**TOWN OF BROOKFIELD
PLAN COMMISSION MINUTES
May 23, 2023**

TOWN OF BROOKFIELD PLAN COMMISSION ZONING REPORT

RE: **Quest Interiors – Final Approval**
21055 Crossroads Circle BKFT1129999007

Strand Associates, Inc.® (Strand) has finished its review of the construction drawings and Storm Water & Erosion Control Calculations resubmittal for the Quest Interiors Development that were received from Excel Engineering, Inc. (Excel) on May 22, 2023, for conformance with the Town specifications and general engineering practices. Before construction may begin, the contractor shall submit all required permits for the development to the state, Wisconsin Department of Natural Resources, Town, and any other relevant agencies. New drawings, stormwater management plan and calculations, and a letter describing the revisions should be returned to Strand after the following concerns have been addressed. Excel's responses to Strand's original comments are *italicized* and Strand's most recent comments are in **bold**.

WET RETENTION POND
NO SCALE

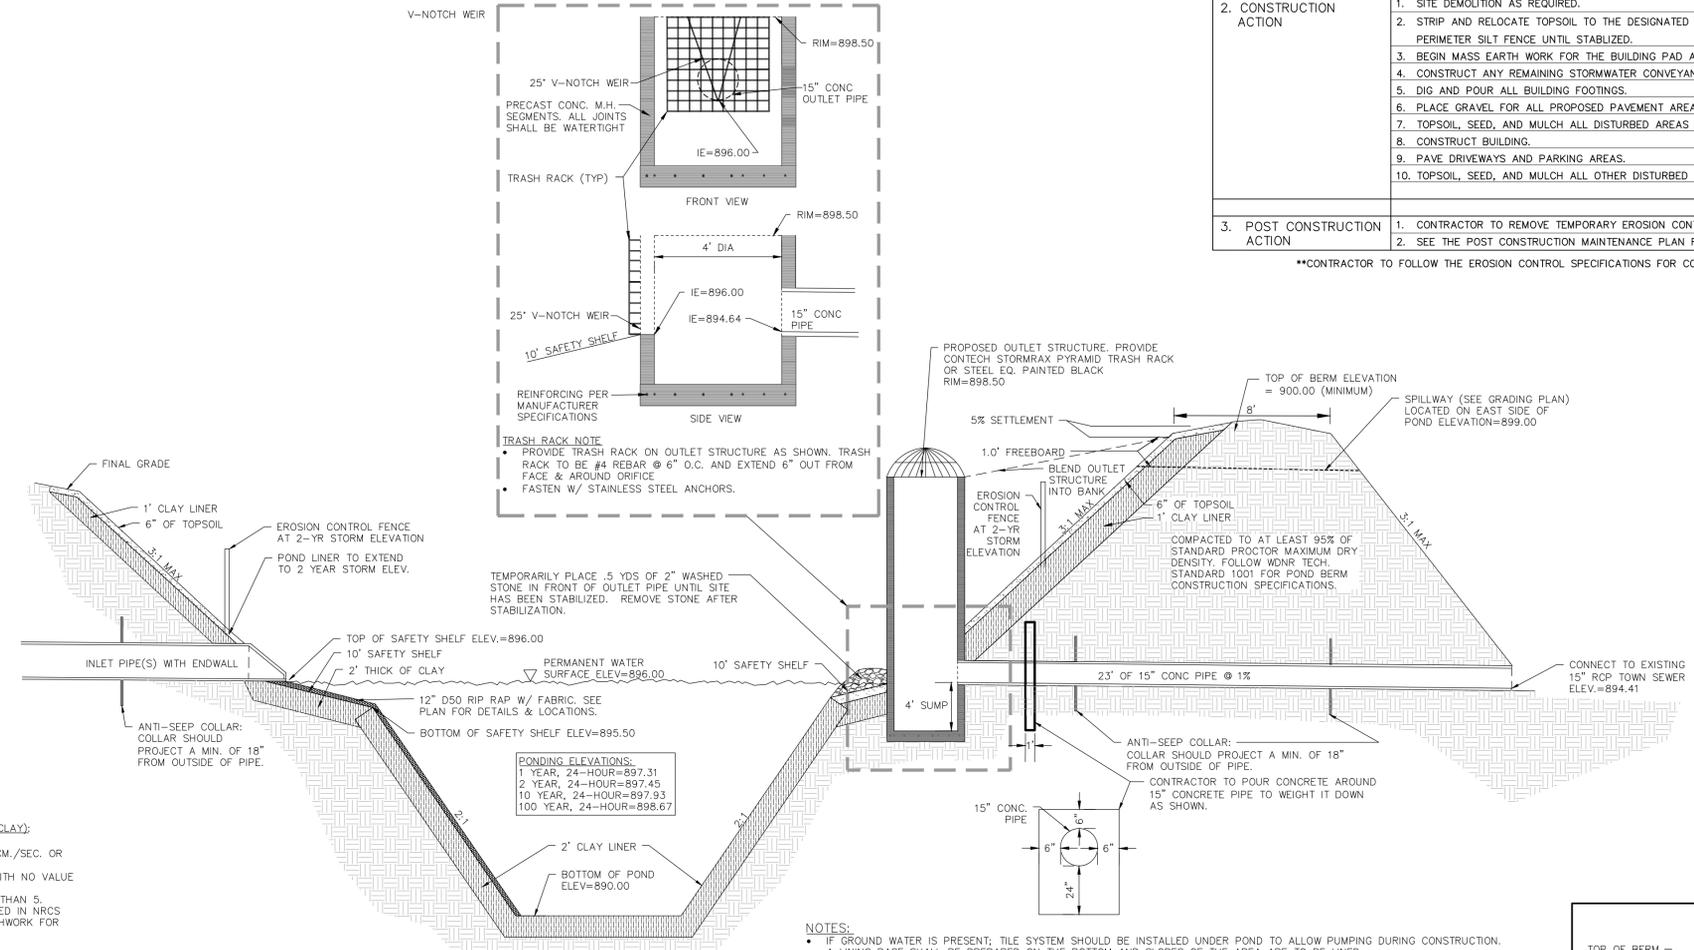
1. Strand's May 3, 2023, Comment—The Wet Retention Pond Detail should include the 2.5-foot rise dimension for the sharp-crested vee weir that is modeled in HydroCAD.

2. Strand's May 3, 2023, Comment—The Wet Retention Pond detail notes a 2-foot sump in the callout for the pyramid trash rack on top of the outlet structure which does not match the callout for a 4-foot sump dimension noted on the bottom of the structure. Detail should be updated accordingly.

3. Strand's May 3, 2023, Comment—The Wet Retention Pond Detail contains callouts for the “2 Year Storm Elev.”. This elevation should be provided on the detail so the contractor knows the exact elevation to install the erosion control fence and pond clay liner.

Excel's May 22, 2023, Response—A rim elevation was added to the V-Notch Weir detail.

Strand's Current Response—It was confirmed a rim elevation was added to the detail.

Excel's May 22, 2023, Response—This has been rectified.

Strand's Current Response—It was confirmed that the 2-foot sump callout was removed.

Excel's May 22, 2023, Response—A note has been added to the detail to provide elevations for design storm events.

Strand's Current Response—It was confirmed that the design storm elevations were added to the detail.
